JOINT REGIONAL PLANNING PANEL

SUPPLEMENTARY REPORT

2 APRIL 2015

Application No.	D/2014/646
Address	30-40 George Street, LEICHHARDT NSW 2040
Proposal	Site preparation works (including diversion of services, demolition of existing structures and excavation), construction of 2 buildings of between 4 and 8 storeys comprising 123 residential units above a 2 level basement car park with 122 parking spaces, and associated works including providing communal open space incorporating a pool, landscaping works, removal of trees, provision of roof gardens with plunge pools, and strata subdivision
Date of Receipt	28 November 2014
Applicant	Stithos Pty Ltd
Owner	Mr T D Rowney
Number of Submissions	116 in opposition
Building Classification	Class 7a, Class 2
Attachment A:	Draft Conditions of Consent

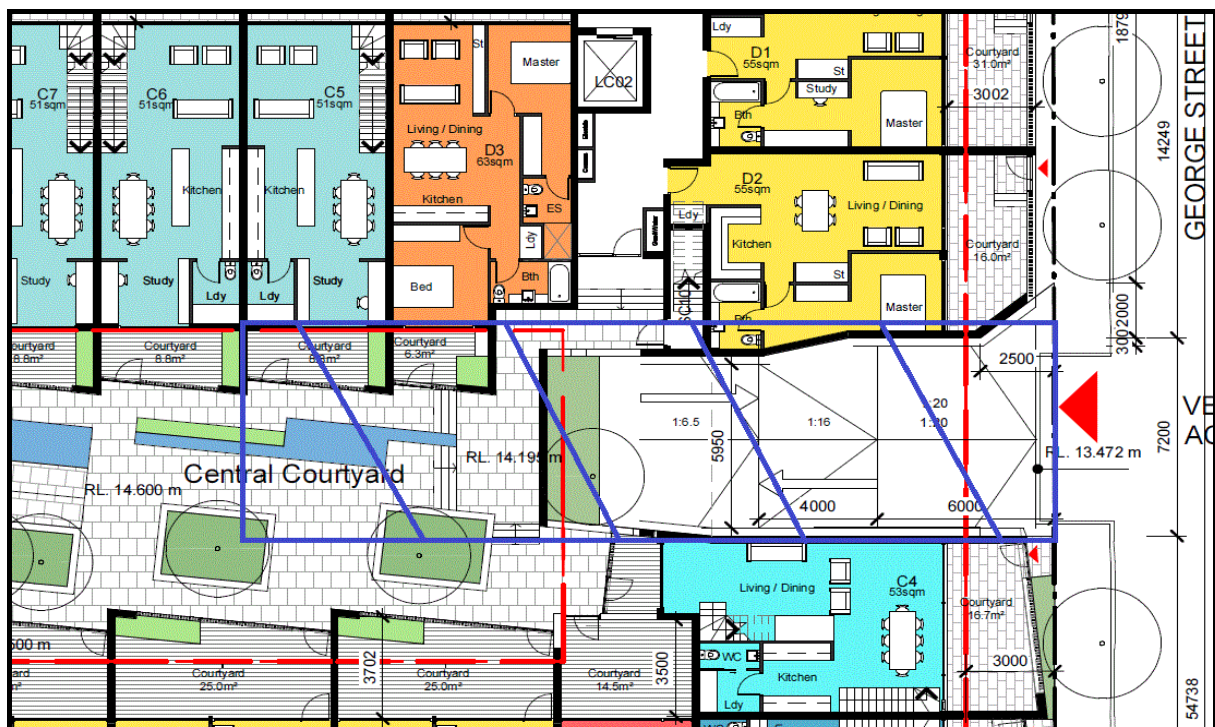
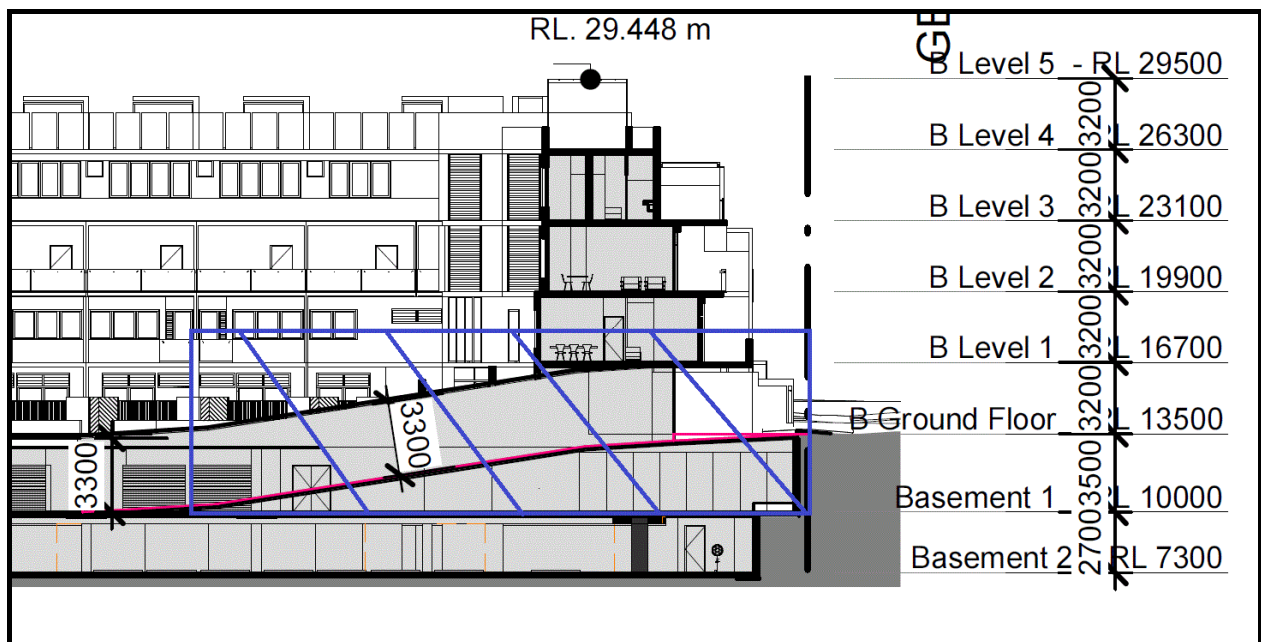
However, it is apparent that the submitted driveway long section contains a number of significant errors and omissions which are detailed below, which gives rise to significant implications on the buildings and structures above the driveway, which have not been reflected on the submitted plans and elevations.

The submitted long section did not include accurate levels to demonstrate the transition of a 3m vehicle from the George Street kerb to the first floor basement in accordance with AS2890.

Council's assessment of the proposed driveway access using the existing road levels has concluded that the design fails to make allowance for the structural beams or ducting above the driveway, nor provide for any structural allowances to construct the landscaping elements to the central courtyard and units above. The area of concern is highlighted in the below graphics.

The impact of the driveway design on the buildings and structures in terms of level changes are demonstrated in the following table:

Required change to building levels in order to comply with AS2890						
	Front Unit D5	Rear ct'yard Unit D3	Central Ct'yard adj D3	Rear ct'yard Unit C5	Central Ct'yard adj D3	Rear ct'yard Unit C6	Central Ct'yard adj D3
Level Change (m)	0.57m	2.31m	1.62m	1.47m	0.37m	0.92m	0.37m

The implications of the above conflicts can be summarised as follows:

- The first floor unit directly above the driveway would need to be raised by approximately 570mm to permit the required headroom or otherwise be deleted.
- The central courtyard would need to be raised approximately 2.31 metres above the adjacent entry foyer which would make the proposed access between them problematic.
- The rear courtyards to units D3, C5 and C6 would need to be raised by 0.92m, 1.47m and 2.31m respectively and would therefore need to be deleted. That is, only windows could be accommodated at the southern end of the units.
- It is unclear whether the 3300mm headroom can be achieved within basement level 1, beyond the access driveway. It may be that basement levels 1 and 2 would need to be lowered, which is able to be addressed.
